Applicant:)	Group Art Unit: 2901
)	
ANTHONY MAGLICA)	Examiner: M. Tung
)	
Serial No. 07/411,576)	
)	
Filed: September 22, 1989)	
)	
For: MINIATURE FLASHLIGHT)

THIRD AMENDMENT AFTER FINAL REJECTION

Fig. 1

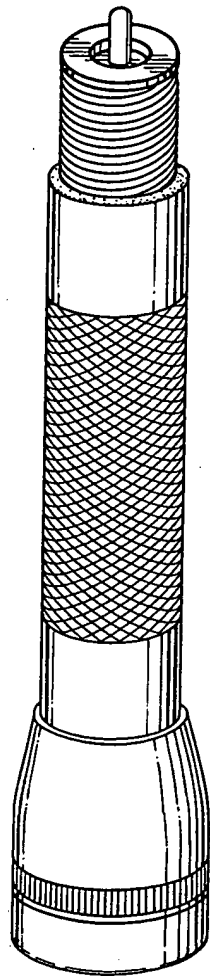
The stippling was questioned on the O-ring. Reference was made to page 8 of the original specification where the O-ring was presented and indicated to be for sealing. It was felt that the representation with the stippling was appropriate. It also appeared on Figure 1 of the first formal drawing.

Fig. 2

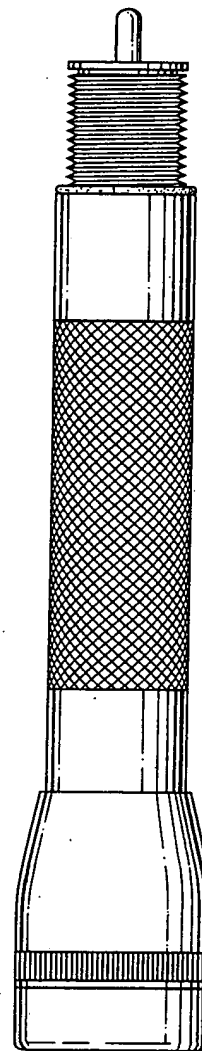
Rather than simply attempt to further sketch changes, the Applicant has prepared a formal drawing. The drawing is intended to include everything submitted in the past as well as reflect the comments from the interview. During the interview, the relative diameter of the threaded portion of the barrel compared with the main portion of the barrel was discussed. The Examiner wanted this relative size to be like the first formal drawing presented in the present application. As noted in the Substitute Declaration of Gerald R. Parker, this has been done.

Applicant is intending to reduce as many issues as possible to leave the single issue of the shape of the flashlight head, i.e., curved versus angled. The relative diameter of the threaded and unthreaded portions of the barrel are according to the Examiner's wishes. The diameters of the added rings in Figures 3 and 4 reflect the shapes in Figures 1 and 2. The threads have been appropriately oriented. Consequently, the drawings are believed to be acceptable with the exception of the head portion as mentioned above.
